PLAN OF PROPOSED IMPROVEMENT

LAKE MENDOTA DR ASSESSMENT DISTRICT - 2023

PROJECT LOCATION CITY PROJECT NO. 14082
CONTRACT NO. 8715

REVISION #1
 REV 05/10/2023
 REVISED/ADDED FOLLOWING SHEETS:
 ADDED: G1-7
 ADDED: SH BOAT LAUNCH 1.0, 1.1
 REVISED: P1-P6
 REVISED: U1-U4, U8-U11, U13-U15, U17-U19
 REVISED: W1-W10

14082
U-2

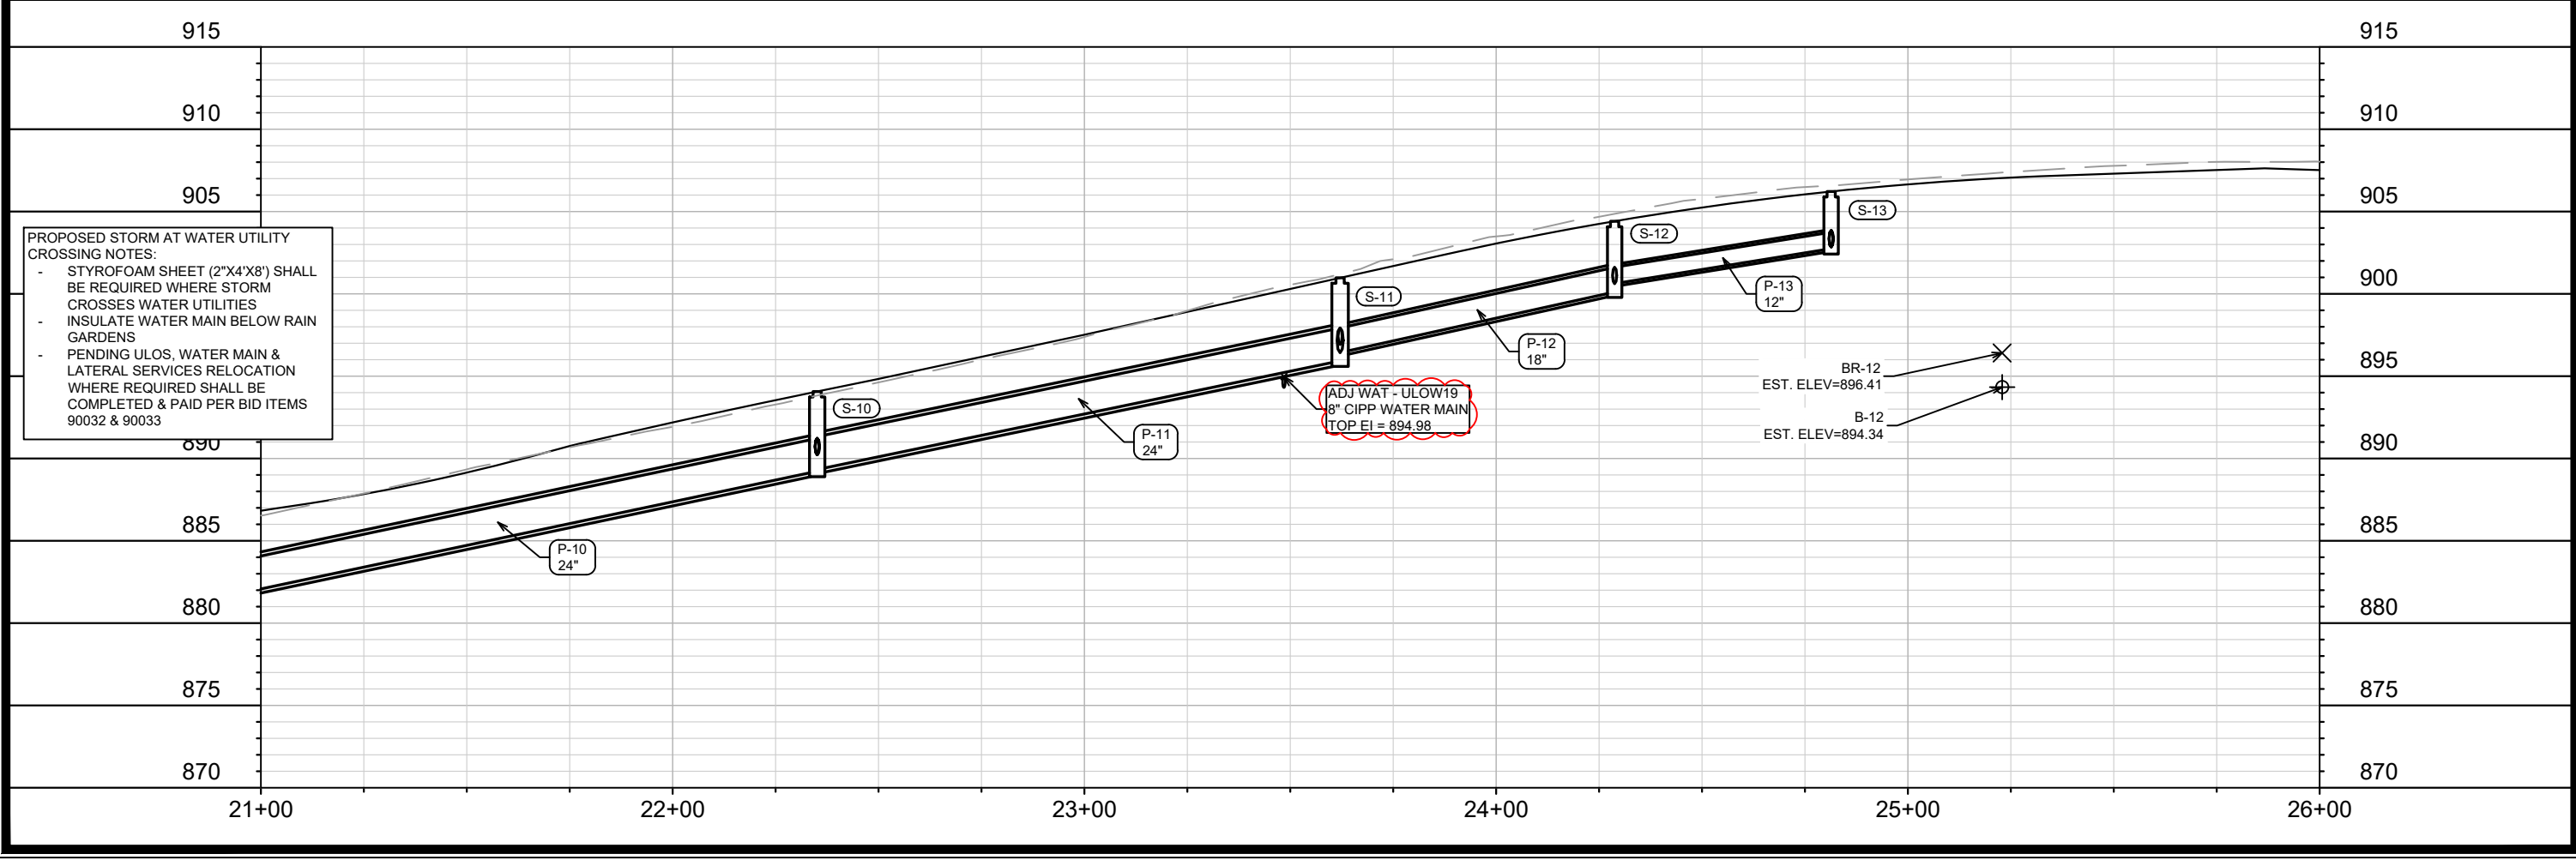
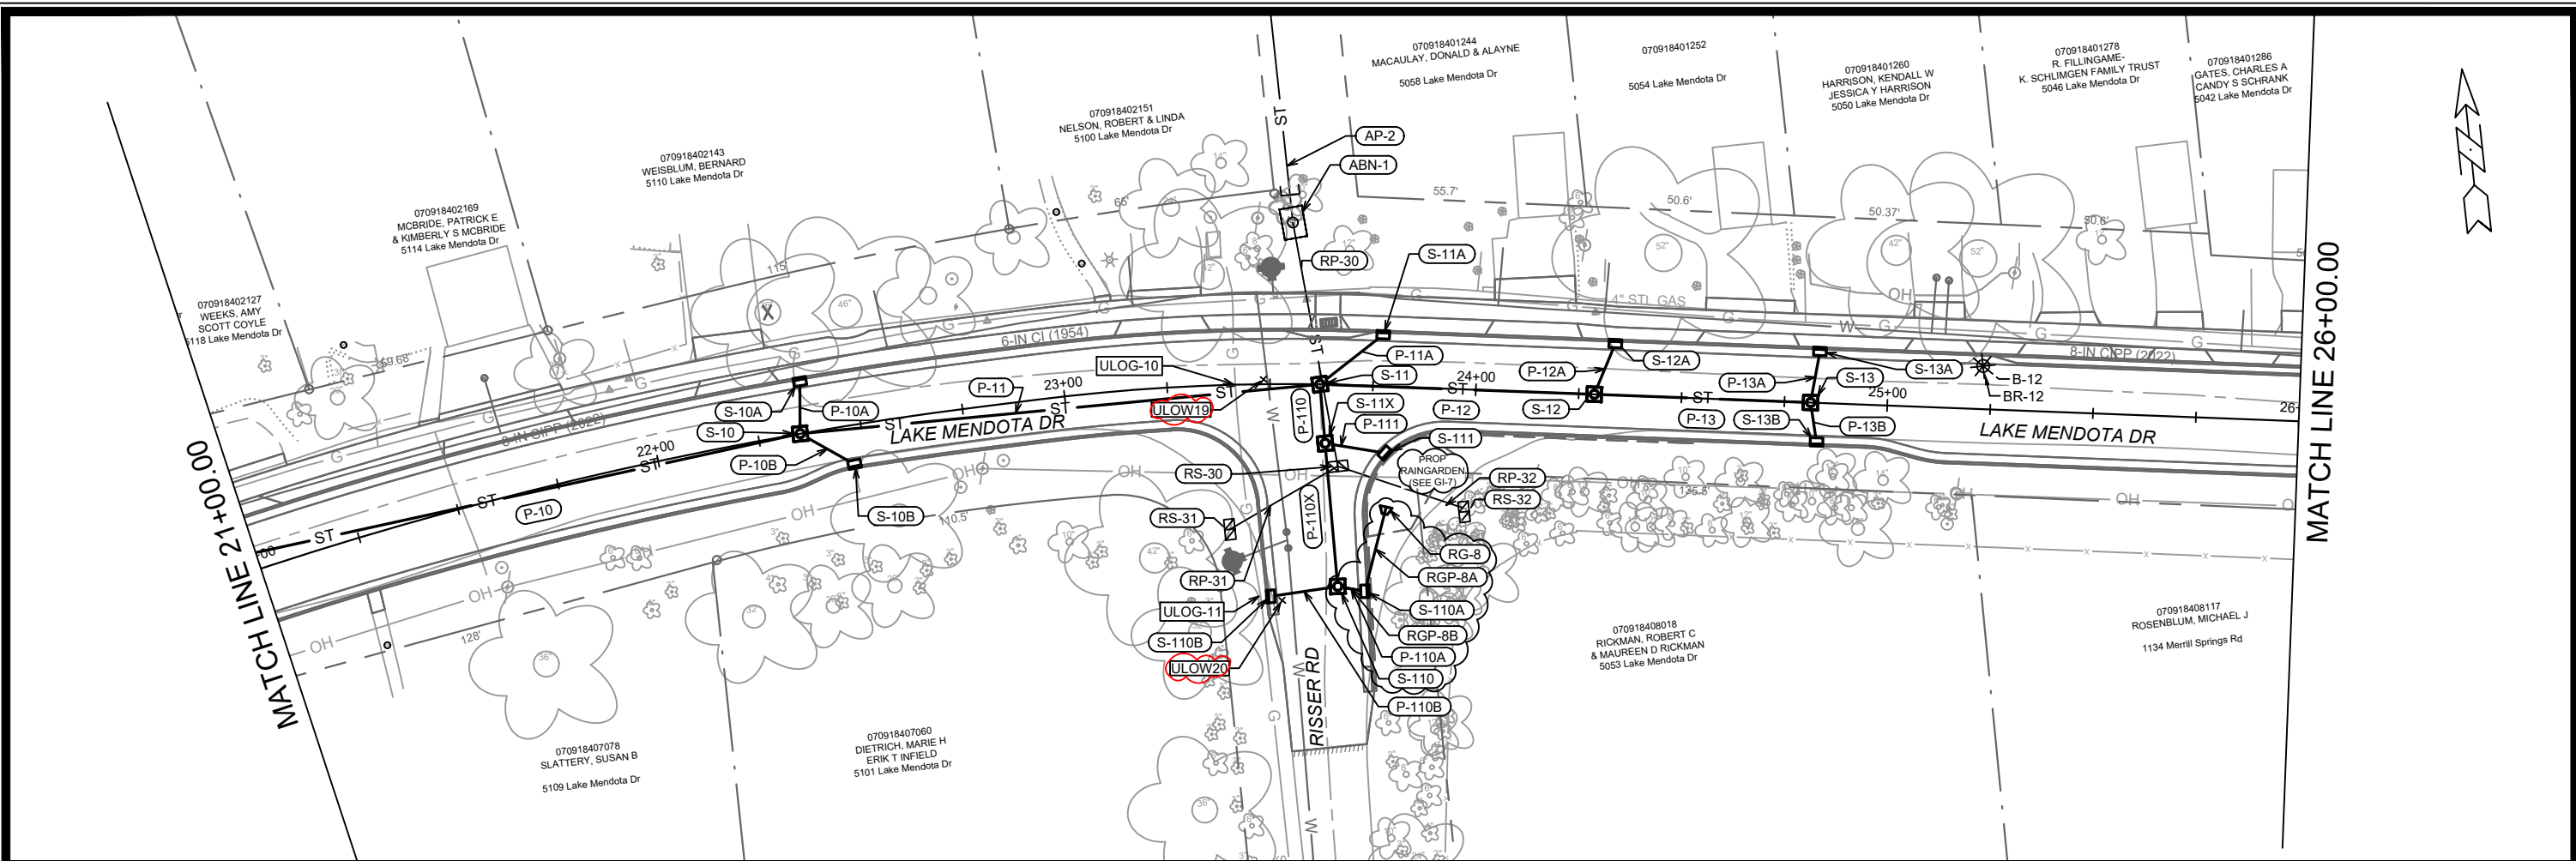
ADDENDUM 1 UPDATE NOTES:
 ADDED RP-9A
 UPDATED P-4, P-5, S-4
 REMOVED S-5C & P-5C
 EX IN3347-024 IS MAPPED, DOES NOT EXIST
 ADDED SUMP NOTE TO S-3
 P-8X RENAMED TO P-9

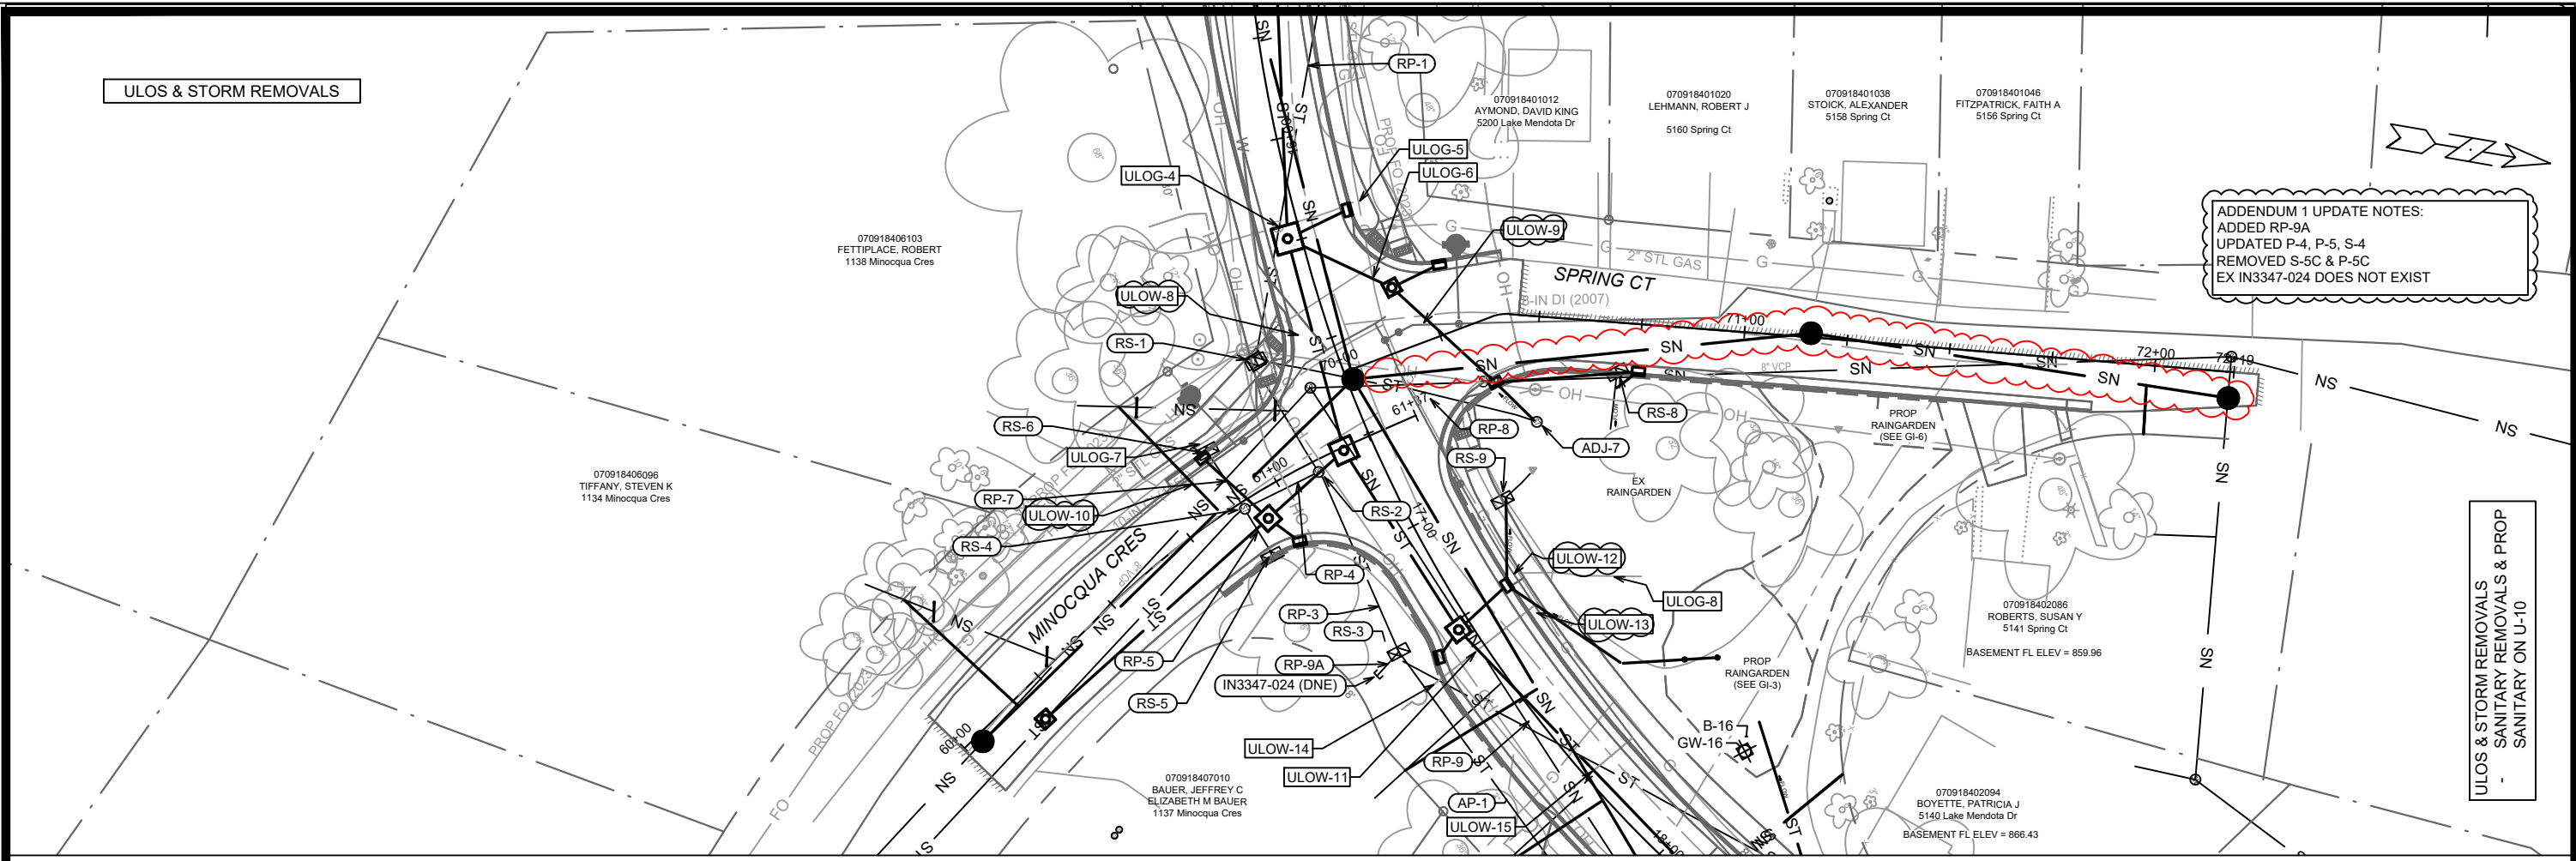
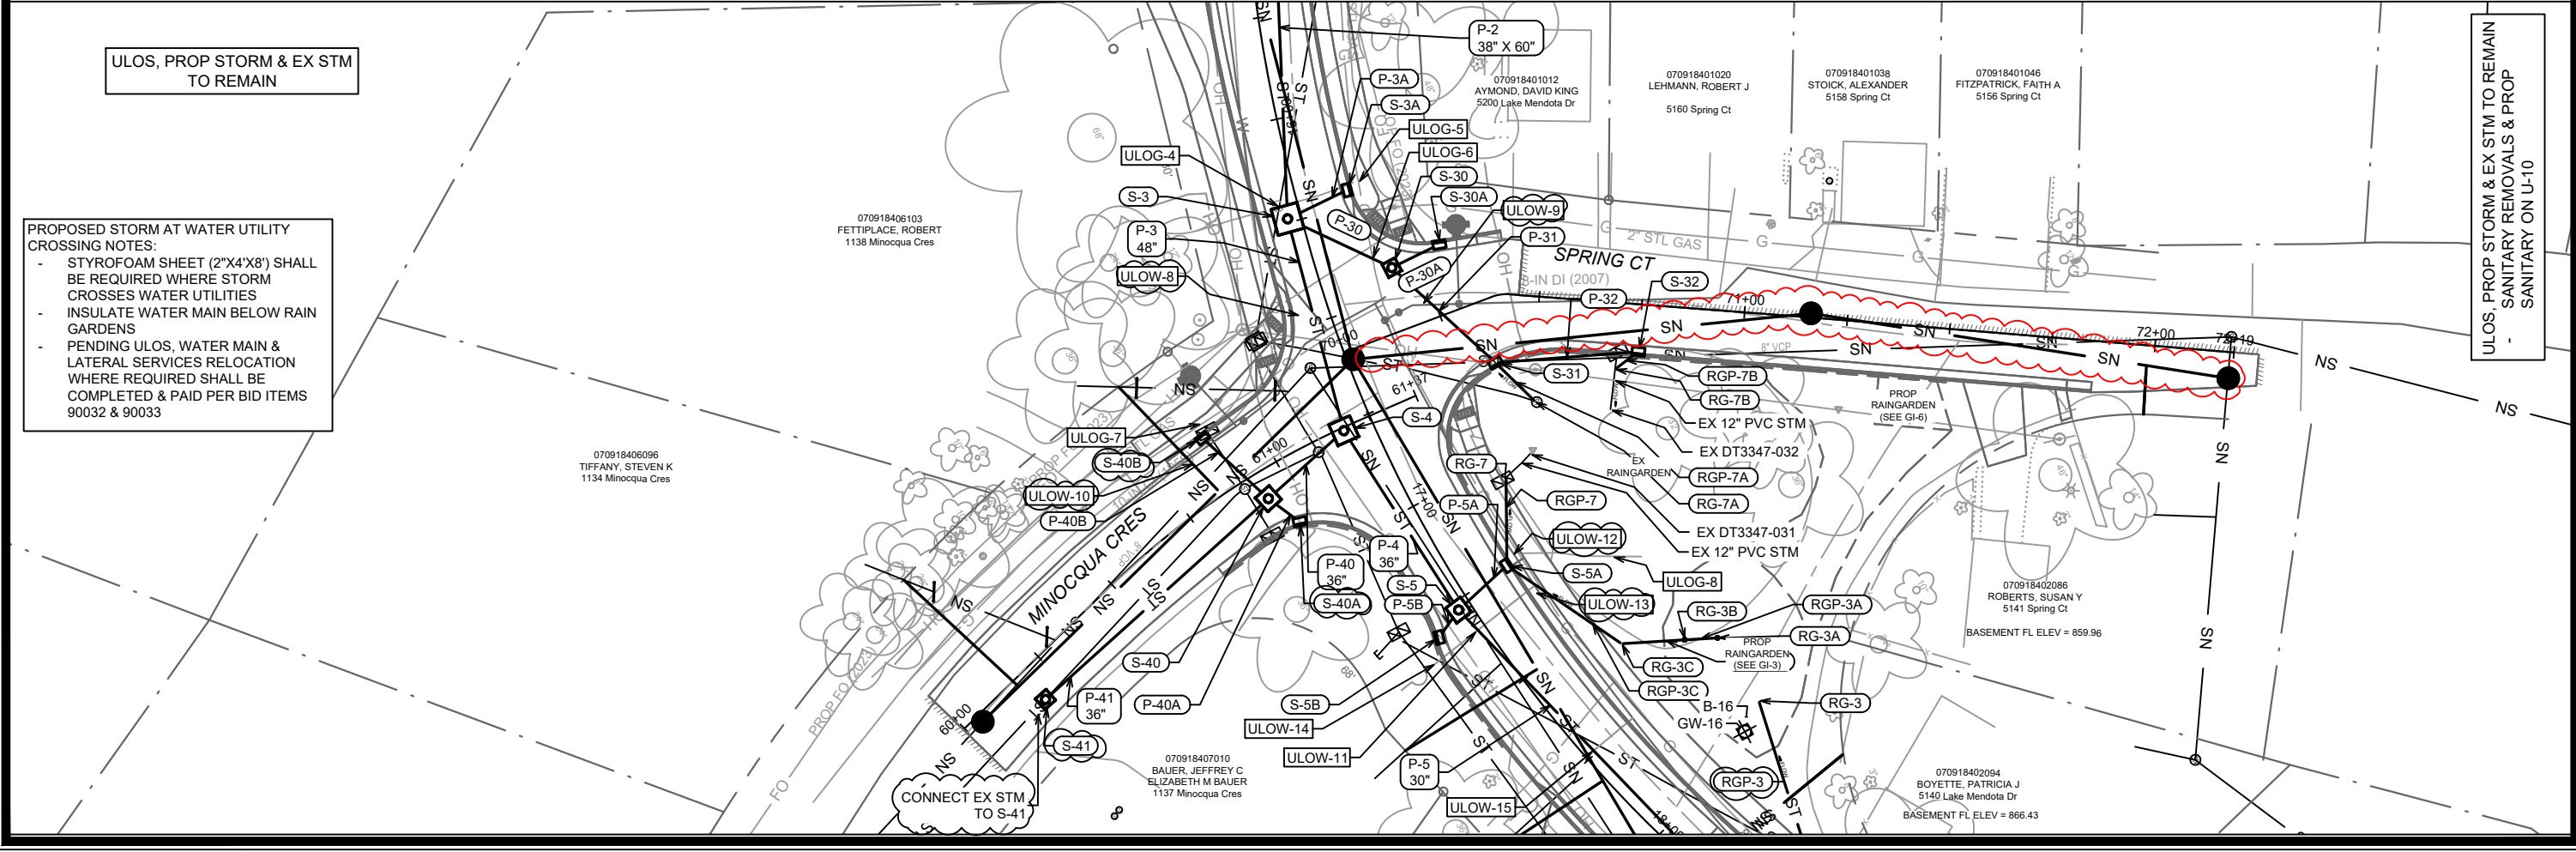
ADDENDUM 1 UPDATE NOTES:
ULOG-1 ADJUSTED
EX GAS ADJUSTED TO MATCH MG&E AS-BUILTS
ULOG-1A ADDED
